**RED HILL VALLEY PARKWAY INQUIRY
RESPONSE REPORT FOR HIGHWAY DESIGN**

Location: Lincoln Alexander Parkway/Red Hill Valley Parkway,
Hamilton, ON
Your File: 51555
Our File: 220488SLB

February 3, 2023

Figure 2: Collision trend for wet surface collisions (Reproduced from the TNS report).

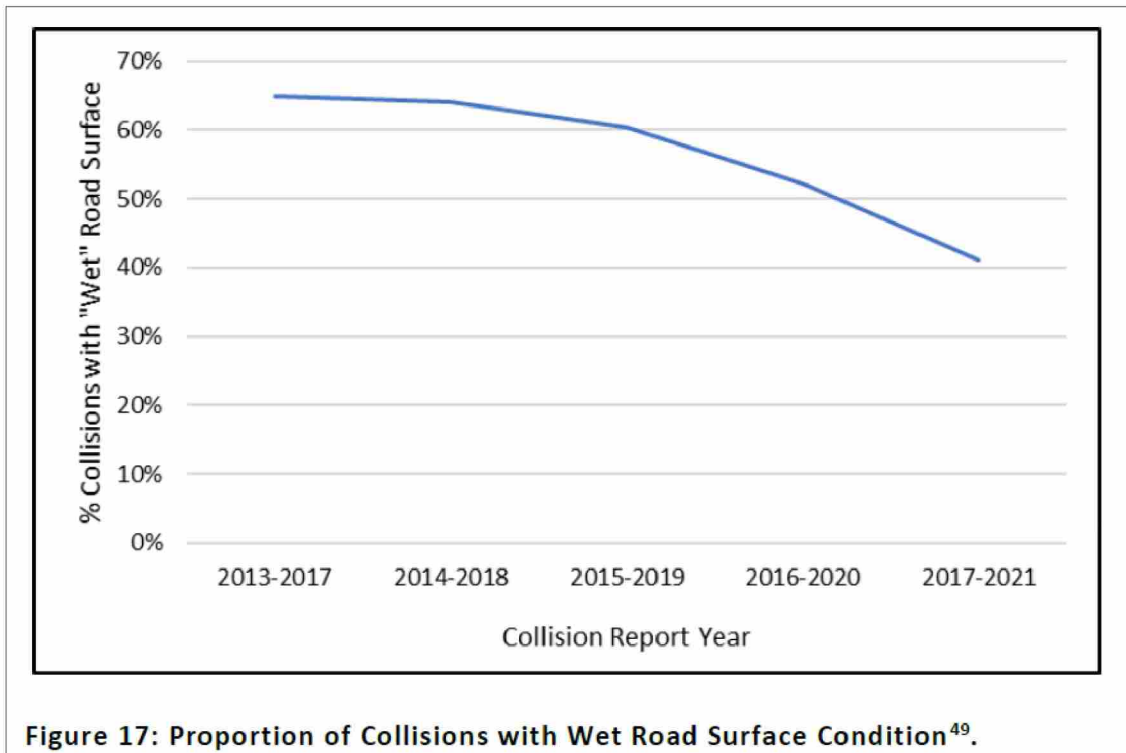
“Figure 17 [reproduced below as Figure 2] shows that the proportion of RHVP collisions with wet road surface conditions slightly decreased between 2017 to 2019, and experienced larger decreases in 2020 and 2021.

It was noted that the RHVP was resurfaced in the Summer of 2019, and subsequent testing in September 2019 found that the friction values were higher compared to friction values collected in 2014. While wet road surface collisions can be impacted by other external factors (i.e., active weather conditions and operating speeds), the proportion of collisions during wet road surface conditions appears to be significantly lower in Q4 of 2019 compared to previous years. This trend generally aligns with the findings shown Figure 17” (reproduced below).

As detailed below (see the following for detail), we do not agree with the TNS report's conclusions for two reasons:

The proportion of wet road condition related collisions were already declining between the 2014-2018 and 2015-2019 periods as illustrated in the TNS report figure reproduced above (Figure 2). Therefore, the conclusions that the 2019 RHVP resurfacing had significantly altered the proportion of wet road related collisions are not supportable, particularly without a proper substantive safety assessment per the prescribed procedure in the HSM, discussed above.

Figure 3: Collision trends for SMV and rear-end collisions on the RHVP (Data Source: City of Hamilton).

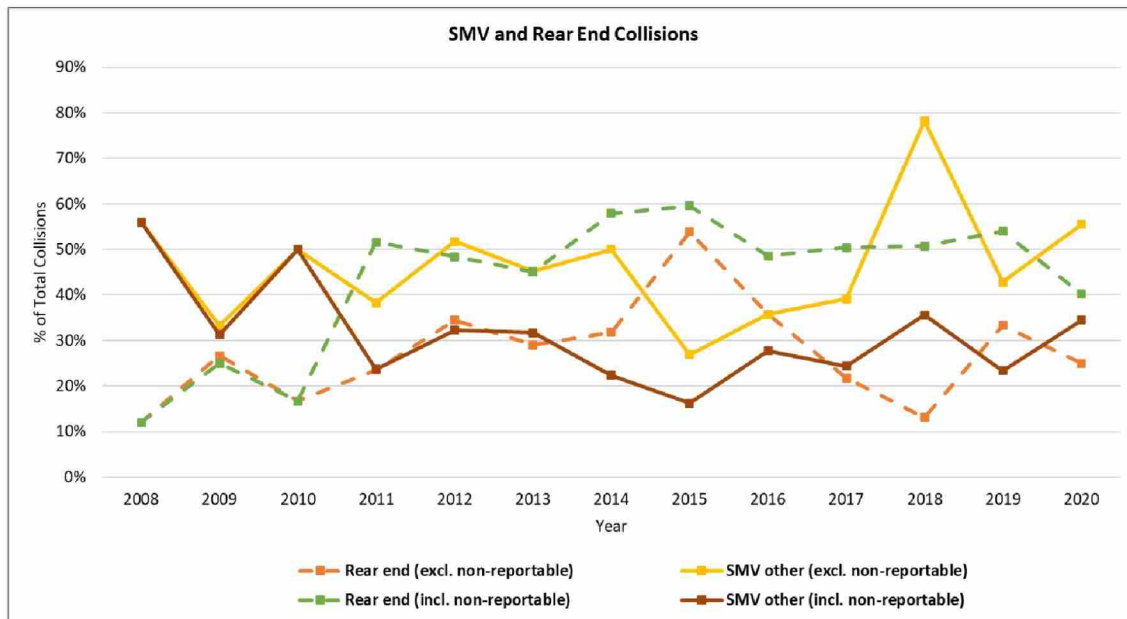
- 1) TNS did not use comparable collision type data for freeways. Specifically, the TNS report did not provide SMV collision rates for freeways from provincial or city-level collision experiences but regardless concluded that the RHVP had a higher proportion of collisions.
- 2) There is no reference or support for the conclusion that rear-end collisions are the most dominant impact type in freeway facilities. In fact, due to the absence of traffic control devices or the lack of intersections, SMV or rear-end collisions are typically common types of collisions on freeways.
- 3) As indicated in our analysis below, our analysis shows that, contrary to the findings in the TNS report, there were no noticeable changes in the rate of SMV collisions when SMV collisions were properly plotted (Figure 3).

The collision trends for these types of collisions are summarized in Figure 3 for all collisions, both excluding and including non-reportable collisions.⁵⁷ Using the total number of collisions that identified an impact type for any specific year, the percentage of rear-end and SMV collisions was estimated for each year from 2008 to 2020 for the RHVP.

There is no significant change in SMV or rear-end collision trends when all collisions are considered. Collisions are random events, so when we look at the standard deviation (the variation from the average value) for single motor vehicle collision sets of data in Figure 4, for instance, the standard deviations vary from 0.11 to 0.15, which means there is small variability of the dataset from the mean. The vertical bars show the standard deviation, and the horizontal line is the average of the data set. The standard deviation shows the variance from the average value. Based on this analysis, we conclude that there was no significant change in major collision types on the RHVP over the past 12 years of operation.
